FINAL SOIL INVESTIGATION LETTER REPORT MELVILLE WATER TOWER SITE NS  
NEWPORT RI  
2/14/2007  
NAVFAC MIDLANT

Subject: FINAL SOIL INVESTIGATION LETTER REPORT,  
MELVILLE WATER TOWER SITE, PORTSMOUTH, RHODE ISLAND

**RESPONSES TO COMMENTS ON THE  
DRAFT SOIL INVESTIGATION LETTER REPORT  
MELVILLE WATER TOWER, PORTSMOUTH RI**

<small>FILE</small> G:\gis_src\PROJECTS\CLEAN\CTO 008\ Melville Water Tower\mwt_grid.apr	<small>SCALE</small> AS NOTED
<small>FIGURE NUMBER</small> <b>FIGURE 5</b>	<small>REV</small> 0
	<small>DATE</small> 11/10/06

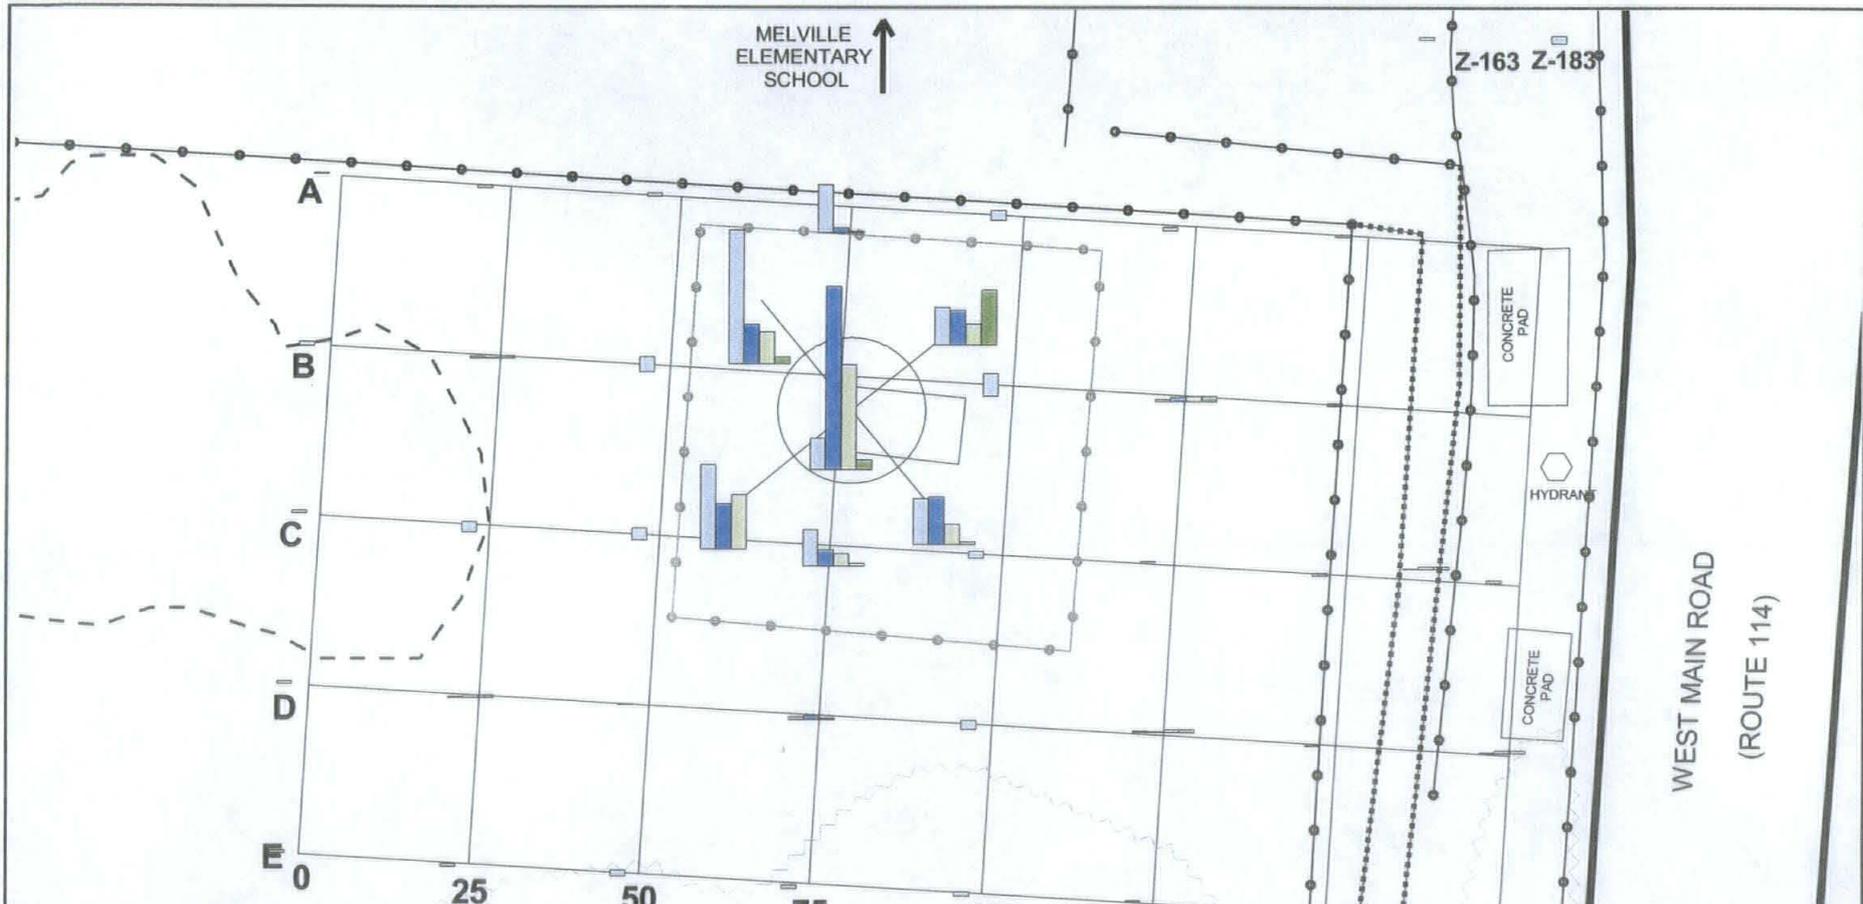
*The first sentence of the second paragraph on page 2 states that samples were collected from the 12-24 in. horizon at 10 sample locations. However, the Field Sampling Plan states that samples would be collected from the 12-24 in. horizon at 14 locations. Is this change due to the sampling near the concrete pad depicted on Figure 5? Justification for the difference between 10 and 14 samples should be provided in the report.*

Response: Samples from the upper intervals were collected with hand tools to assure adequate volume, without sample recovery problems. Samples from the 12-24 inch interval were collected with a hydraulic direct-push technology soil probe system (DPT). However, at two locations (D175, and C162) the DPT rig could not gain access due to fencing and guard rails, and the depth interval of 12-24 inches was not achievable using hand tools. Additionally, the deep samples at location A75 and F2 (southwest tower footing) were attempted using DPT but not acquired due to poor recovery at the target interval despite repeated attempts. The large amount of gravel underlayment interfered with deep sample acquisition. This will be clarified in the final report.
